Modified Access Routes April 2016

Figure 2

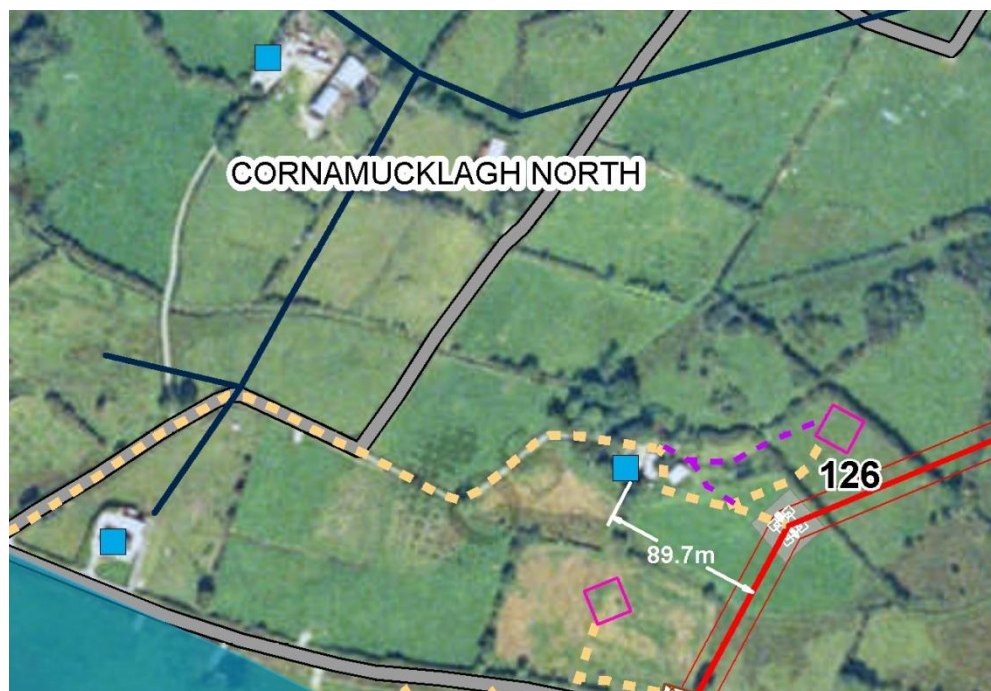
Environmental Review Topic	Tower 126 Access Route Comment
Ecology	The access route delineated in purple avoids the requirement to remove a mature tree and also a hedgerow crossing at a reported badger sett. The route crosses improved agricultural land using an existing track and field entrance to the stringing location. There is no change to the overall ecological impact evaluation; the impact is evaluated as imperceptible in the local context.
Cultural Heritage	There are no additional cultural heritage issues regarding the alternative temporary access to Tower 126.
Traffic	Access to Tower 126 is still accessed via the L34201. No change to traffic movements.
Water/Soils/Geology	No significant issues with either access route option.
Agronomy	There is no significant difference between the access route delineated in purple and the access route as submitted in the application and there will be no change in the impact evaluation.

Figure 3

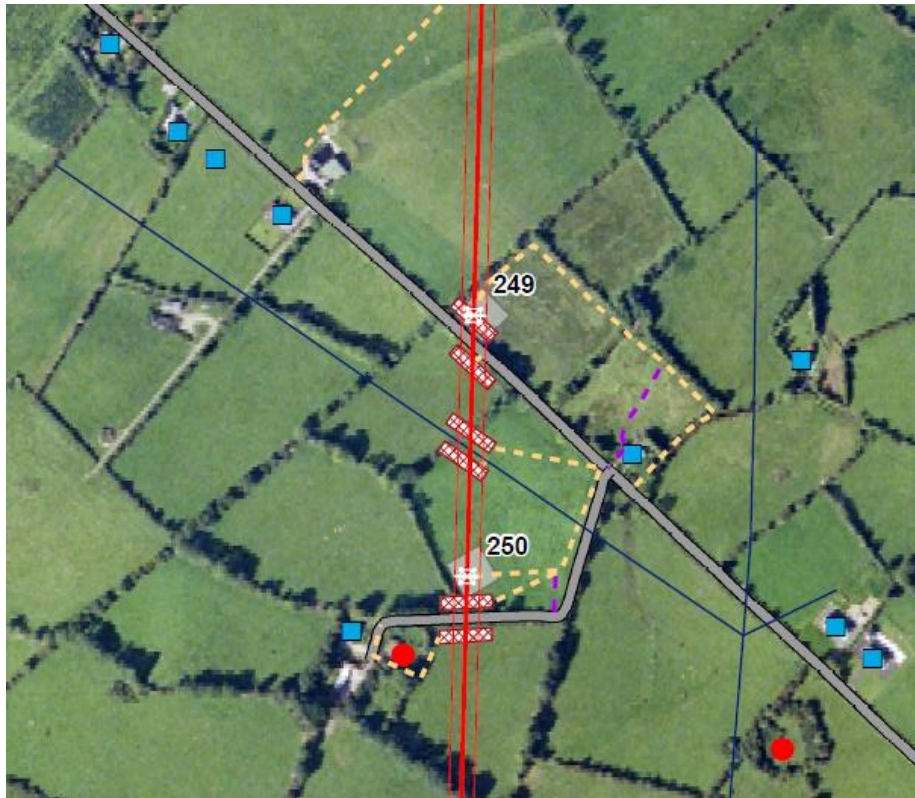
Environmental Review Topic	Tower 249 Access Route Comment
Ecology	The access route delineated in purple uses an existing field entrance via a gate off the main road and crosses improved pasture to the tower location. There is no change to the overall ecological impact evaluation.
Cultural Heritage	There are no additional CH considerations for this location.
Traffic	Access to Tower 249 is still accessed via the L68011. No change to traffic movements.
Water/Soils/Geology	No significant issues with either access route option.
Agronomy	The access route delineated in purple utilises an existing entrance to the field and it crosses the field rather than using an existing laneway. The access route delineated in purple will not change the impact evaluation.

Figure 4

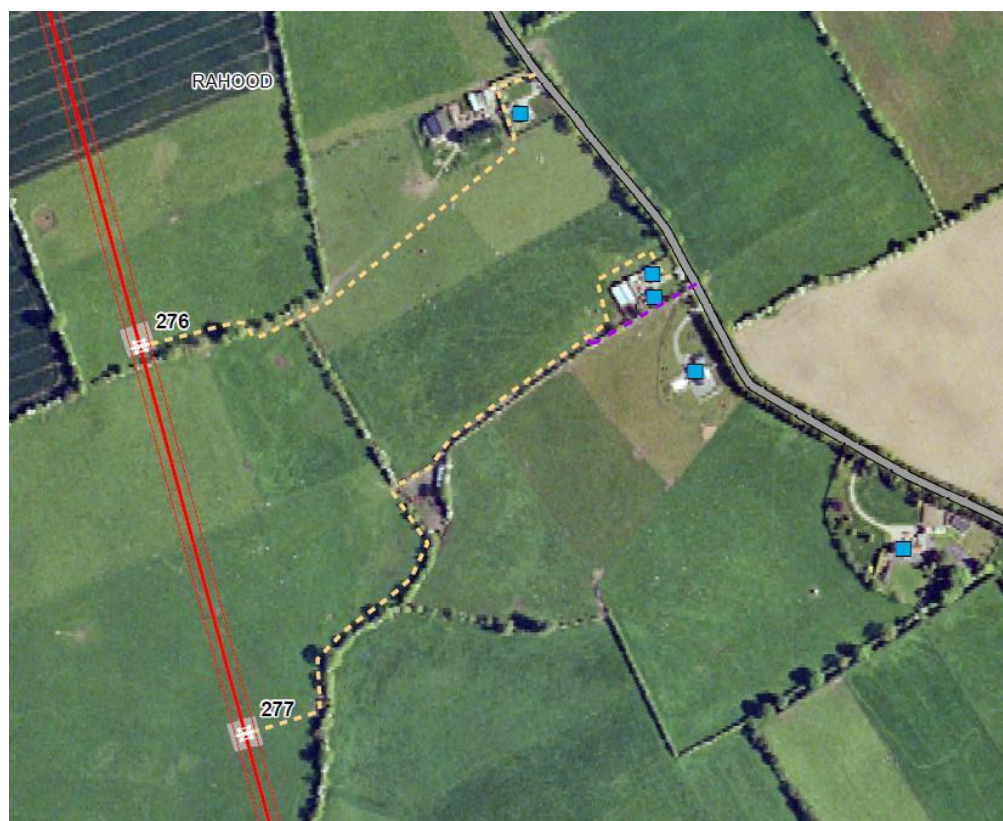
Environmental Review Topic	Tower 277 Access Route Comment
Ecology	The access route delineated in purple uses an existing laneway entrance off the main road. It crosses improved pasture and an existing hedgerow gap to the tower location. There is no change to the overall ecological impact evaluation.
Cultural Heritage	The route delineated in purple is a minor adjustment to the original access route. As with the original, the route follows a townland boundary wall towards the tower location. There are no CH considerations for this location.
Traffic	Access to Tower 277 is still accessed via the L34021. No change to traffic movements.
Water/Soils/Geology	No significant issues with either access route option.
Agronomy	There is no significant difference with the access route delineated in purple. The access route delineated in purple will not change the impact evaluation.

Figure 6

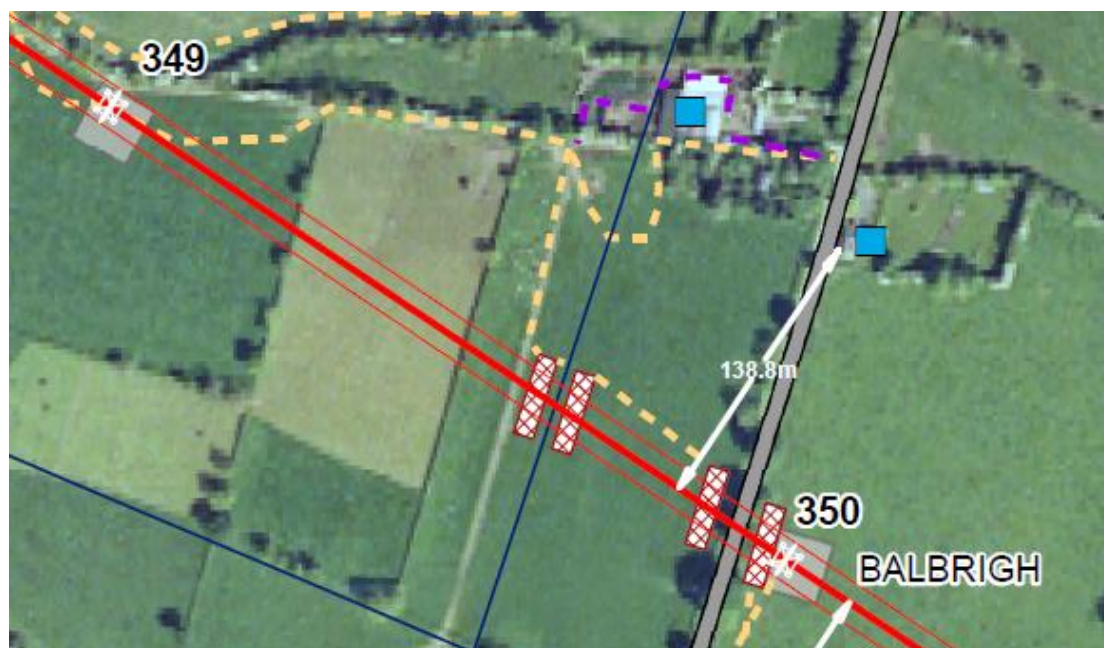
Environmental Review Topic	Tower 349 Access Route Comment
Ecology	The access route delineated in purple uses an existing laneway entrance off the main road. It follows an existing farm access route and access track to improved agricultural grassland to the tower location. There is no change to the overall ecological impact evaluation.
Cultural Heritage	There are a number of farm buildings depicted on the 1 st Edition Map in the vicinity of both the modification and the existing route. Any extant vernacular features should be demarcated and avoided.
Traffic	Access to Tower 349 is still accessed via the L40071. No change to traffic movements.
Water/Soils/Geology	No significant issues with either access route option.
Agronomy	There is no significant difference with the access route delineated in purple. The access route delineated in purple will not change the impact evaluation.

Figure 9

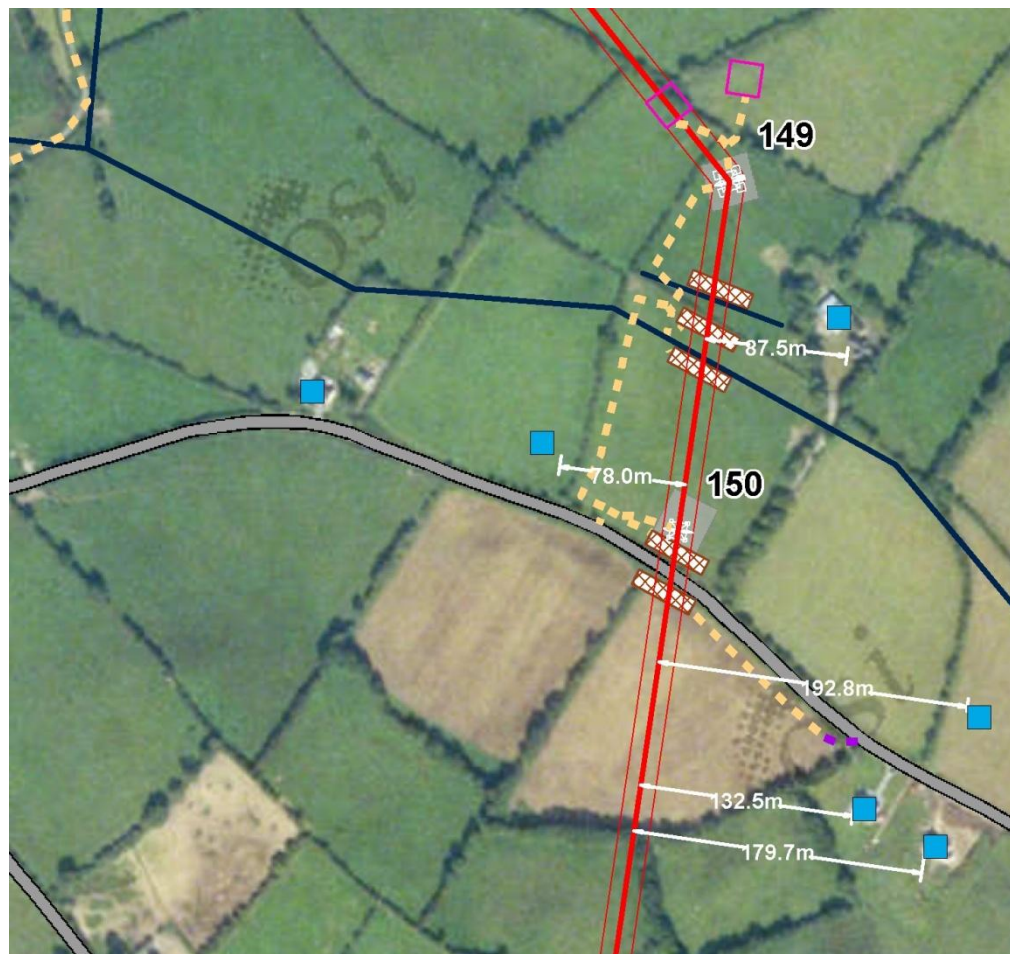
Environmental Review Topic	Guarding South of Road Span 150 – 151 Access Route Comment
Ecology	The access route delineated in purple crosses improved pasture and utilises an existing entrance to the road. There is no change to the overall ecological impact evaluation, as the impact remains imperceptible.
Cultural Heritage	There are no additional CH considerations for this location.
Traffic	Access to guarding between Towers 150 and 151 south of the L7211 is still accessed via the L7211 No change to traffic movements.
Water/Soils/Geology	No significant issues with either access route option.
Agronomy	The access route delineated in purple utilises an existing entrance to the field and requires a slightly longer route length. The access route delineated in purple will not change the impact evaluation.

Figure 11

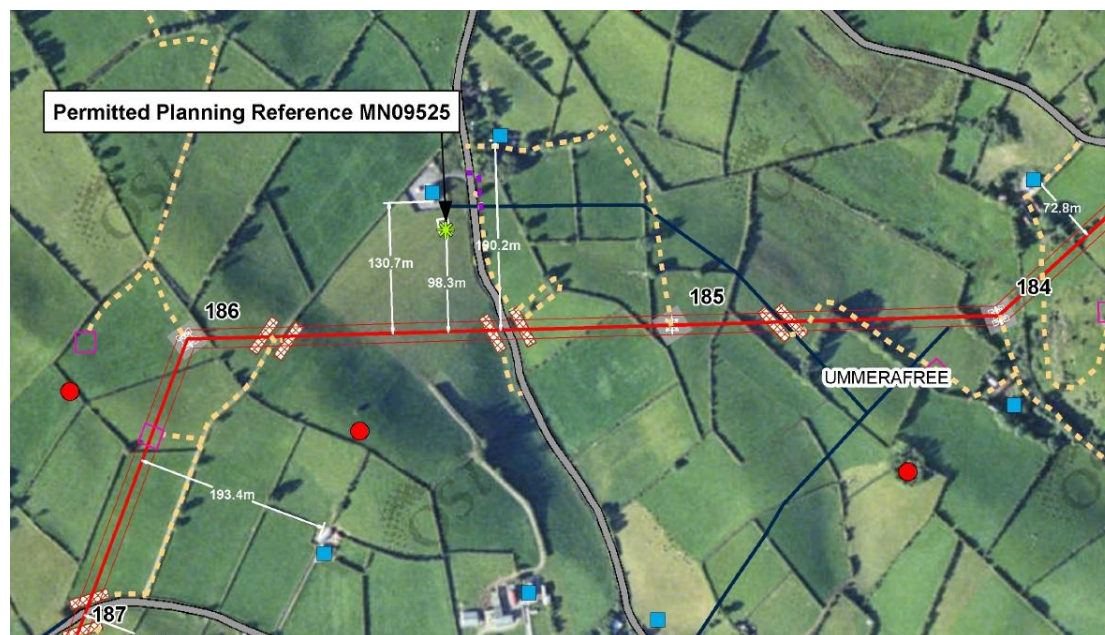
Environmental Review Topic	Span 185-186 Access Route Comment
Ecology	The access route delineated in purple uses an existing field entrance from the main road. The route delineated in purple avoids direct disturbance to a low value hedgerow at the roadside. There is no change to the overall ecological impact evaluation.
Cultural Heritage	There are no additional CH considerations for this location.
Traffic	Access to guarding on east side of L40121 is still accessed via the L40121. No change to traffic movements.
Water/Soils/Geology	No significant issues with either access route option.
Agronomy	The access route delineated in purple utilises an existing entrance to the field and requires a slightly longer route length – staying close to the same field boundary. The access route delineated in purple will not change the impact evaluation.

Figure 13

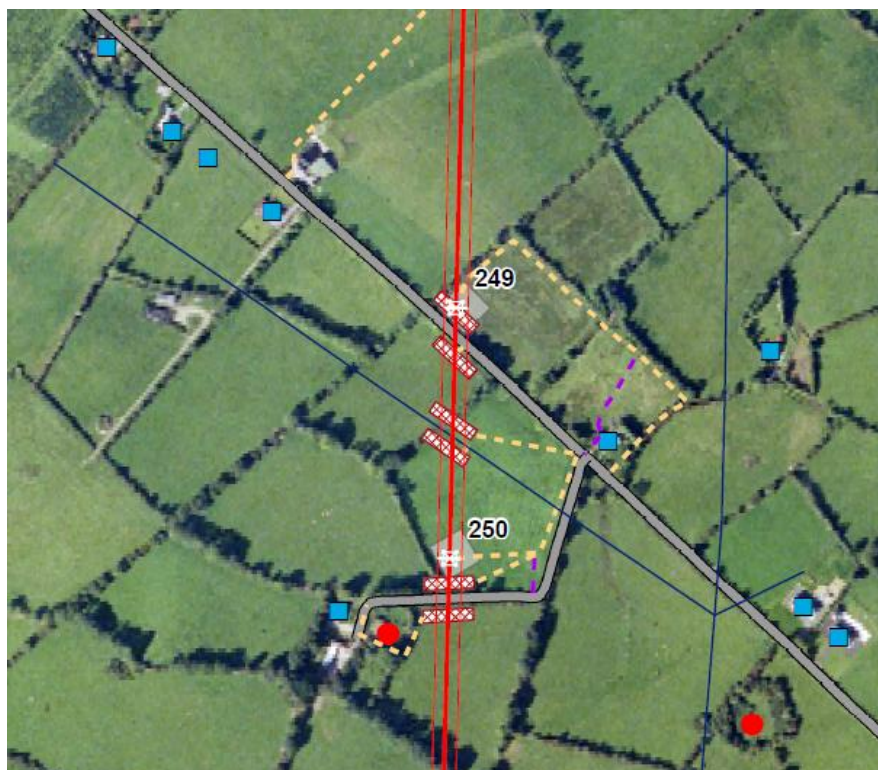
Environmental Review Topic	Tower 250 and Guarding Access Route Comment
Ecology	The access route delineated in purple uses an existing field entrance off the public road and crosses improved agricultural grassland to the tower location, avoiding disturbance to low value hedgerow at the roadside. There is no change to the overall ecological impact evaluation.
Cultural Heritage	The access route delineated in purple is a minor adjustment to the access route originally shown in an area where there are no previously recorded archaeological or architectural heritage features at the location of the access route. There are no cultural heritage issues with the access route delineated in purple.
Traffic	Access to Tower 250 and guarding is still accessed via the L68016. No change to traffic movements.
Water/Soils/Geology	No significant issues with either access route option.
Agronomy	There is no significant difference with the access route delineated in purple. The access route delineated in purple will not change the impact evaluation.

Figure 17

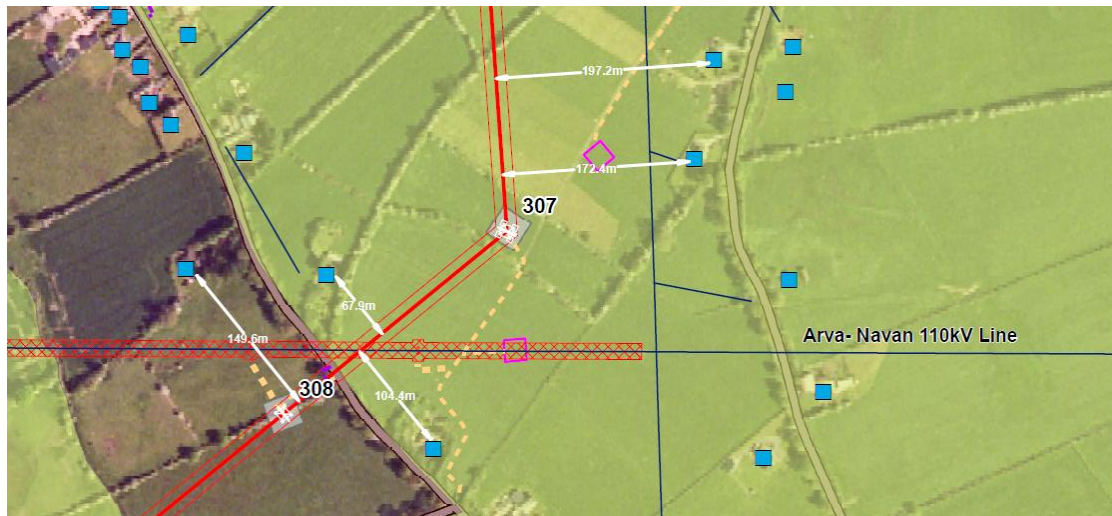
Environmental Review Topic	Tower 308 Access Route Comment
Ecology	The access route delineated in purple uses an existing entrance off the main road. It crosses improved pasture to the tower location. There is no change to the overall ecological impact evaluation.
Cultural Heritage	There are no CH considerations for this location.
Traffic	Access to Tower 308 is still accessed via the L3409. No change to traffic movements.
Water/Soils/Geology	No significant issues with either access route option.
Agronomy	There is no significant difference with the access route delineated in purple. The access route delineated in purple will not change the impact evaluation.
